KETCHIKAN, ALASKA GRAVINA ISLAND HIGHWAY

KTN GRAVINA-MILL ACCESS ROAD
PROJECT NO. Z699220000

*Asbuits
Contractor: Glacier State Contractors
Start Date: 6/7/16
End Date: 10/27/16*

RESURFACING

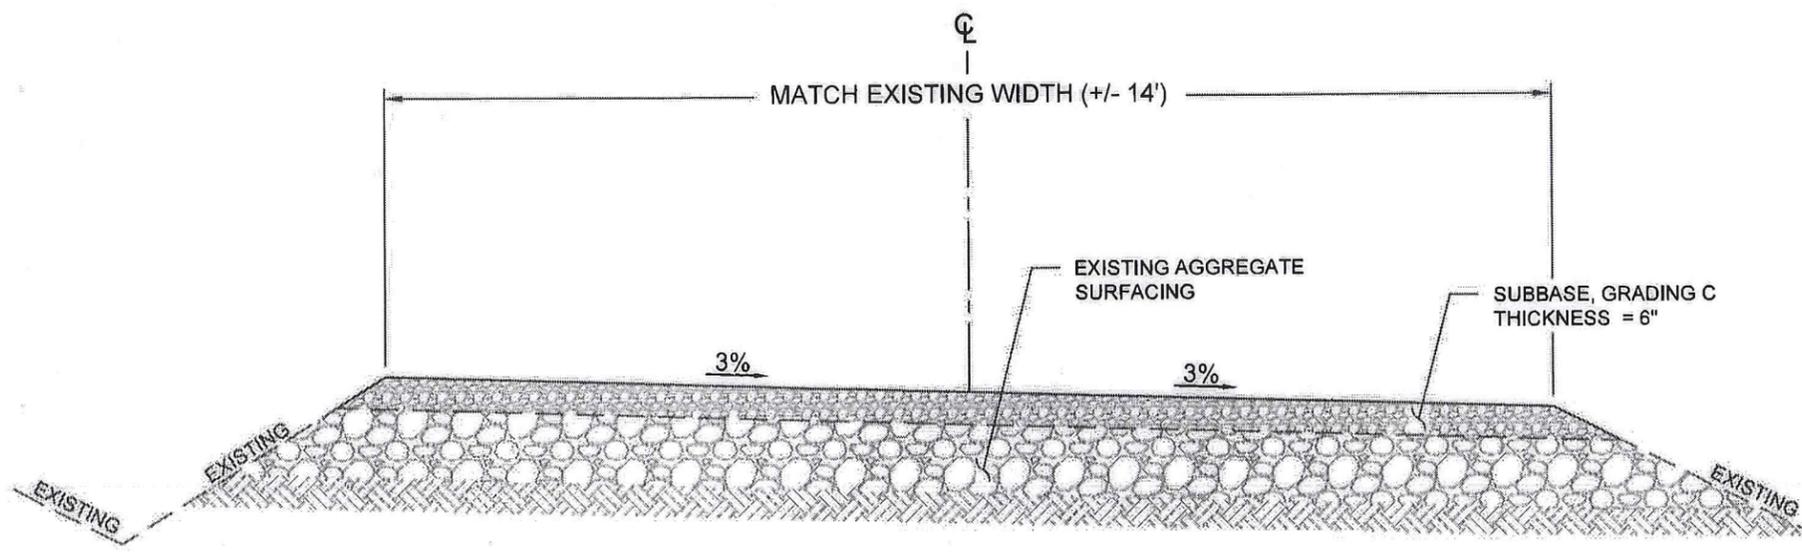
*Revision: See 2 sheets
 STN 300+00 - 309+86
 lay back slopes to 1.5:1
 to adjust from a rock cut
 to a soil cut*

**PLAN AND PROFILE
 SITE 2**

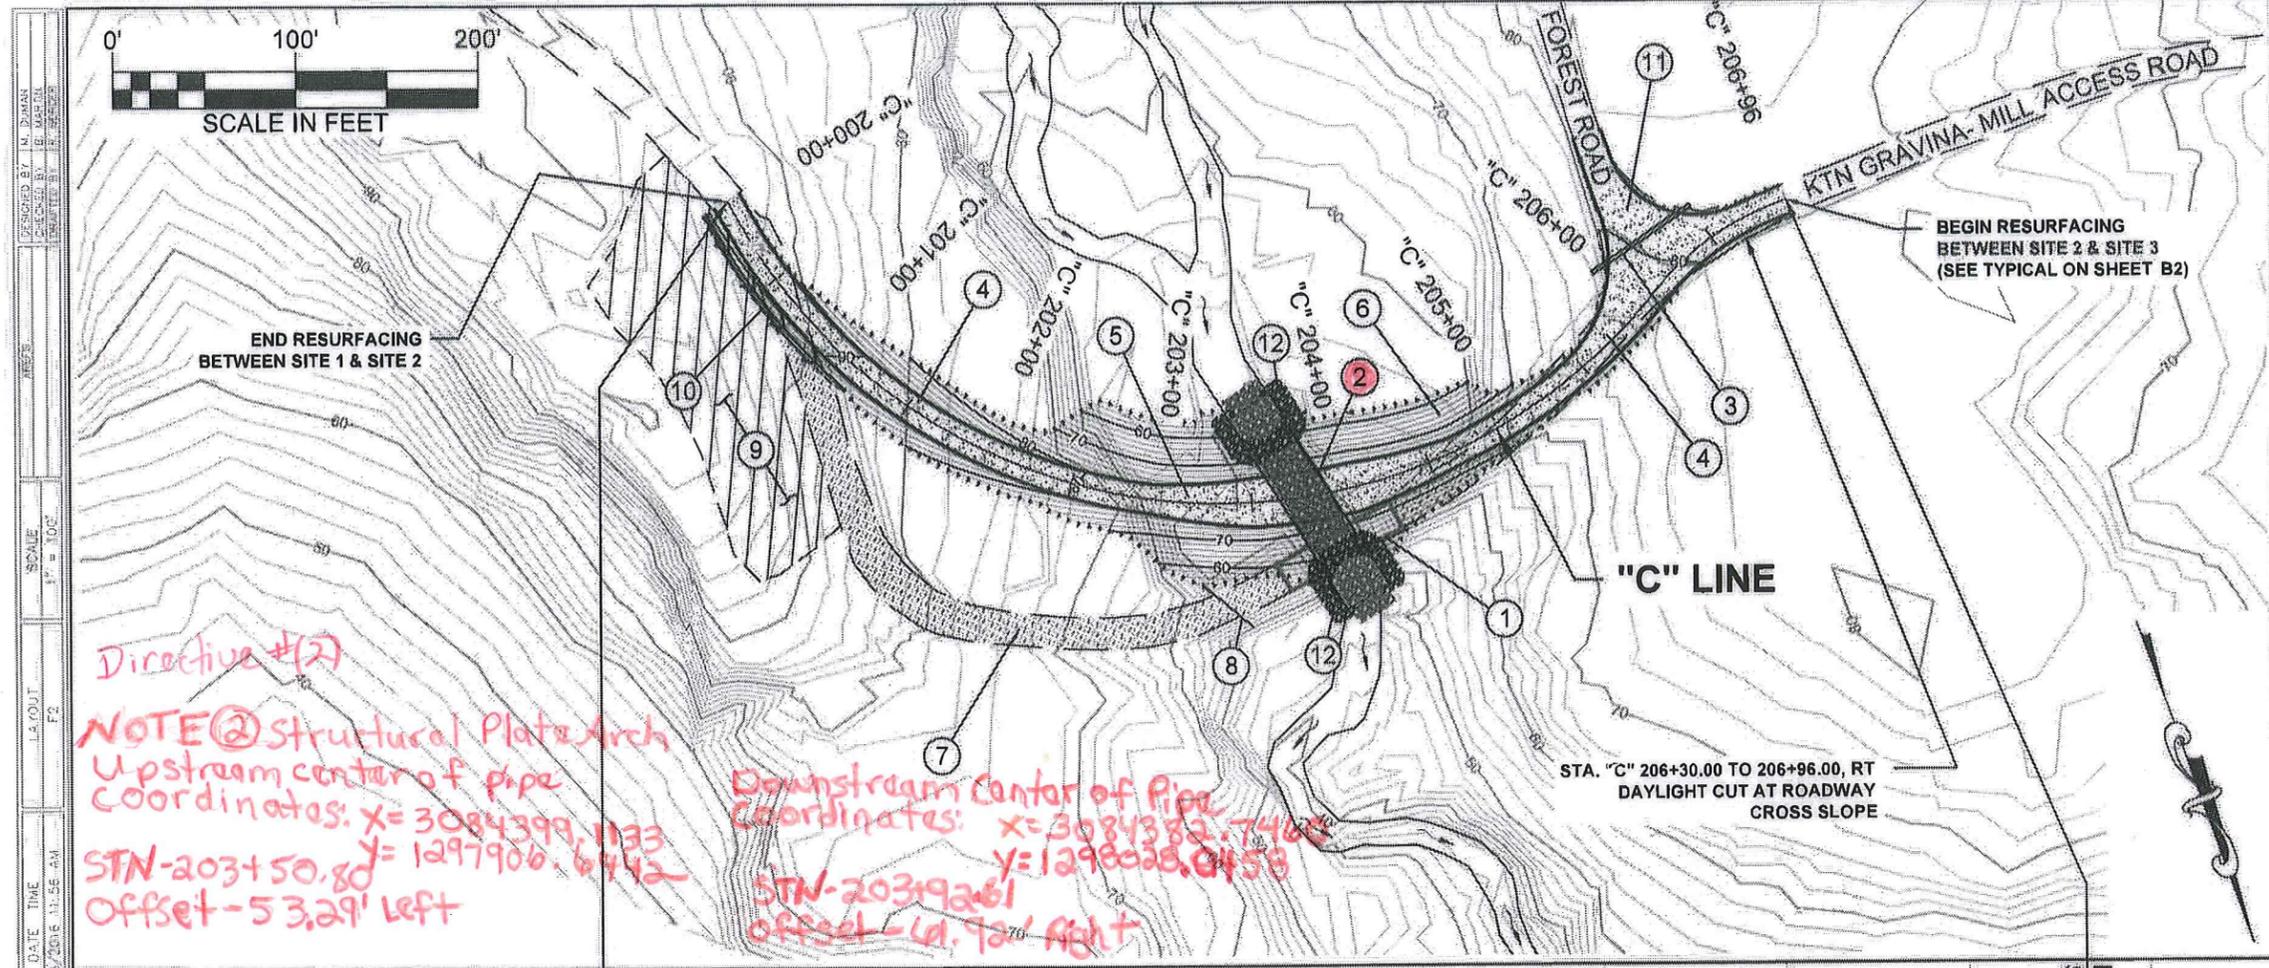
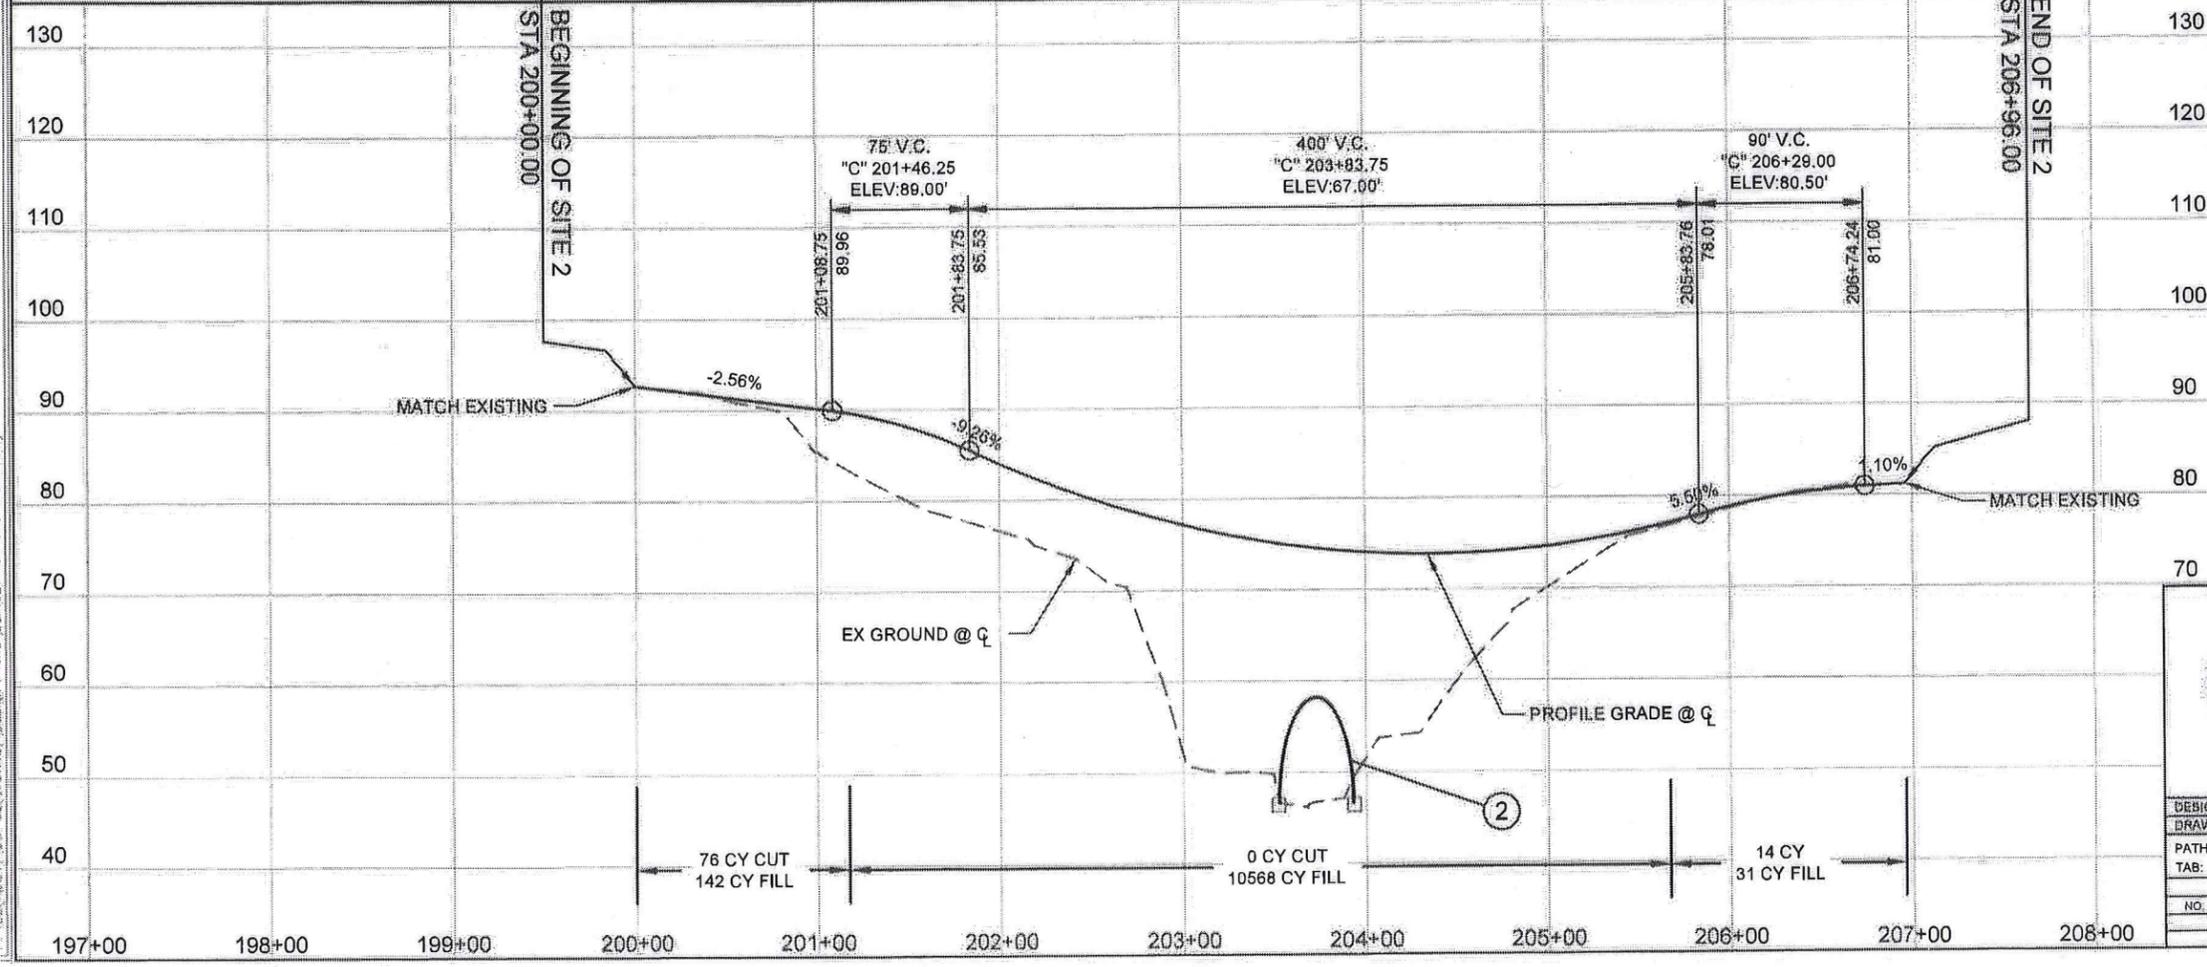
NOTE @ Structural Plate Arch
 Upstream center of pipe
 Coordinates: $x = 3084399.1133$
 $y = 1297906.6942$
 STN-203+50.80
 Offset - 53.29' left

Downstream center of pipe
 Coordinates: $x = 3084382.7468$
 $y = 1298028.0458$
 STN-203+92.61
 Offset - 41.92' right

(SITE 2) STA. "C" 203+79.62

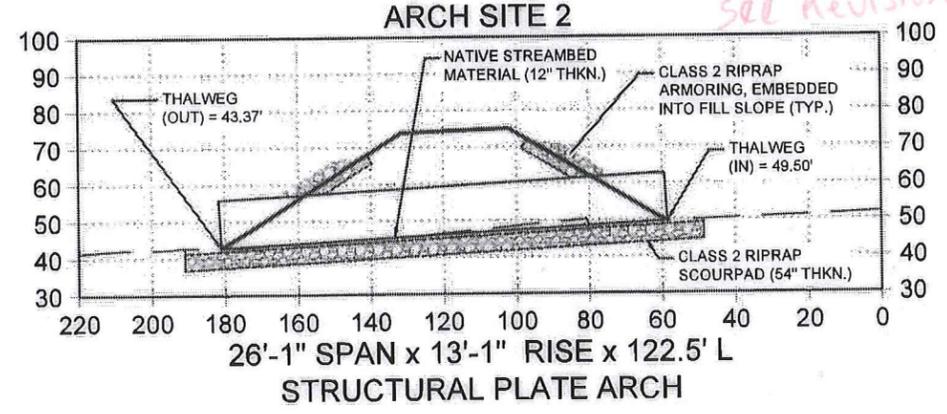
See Revision sheet F2
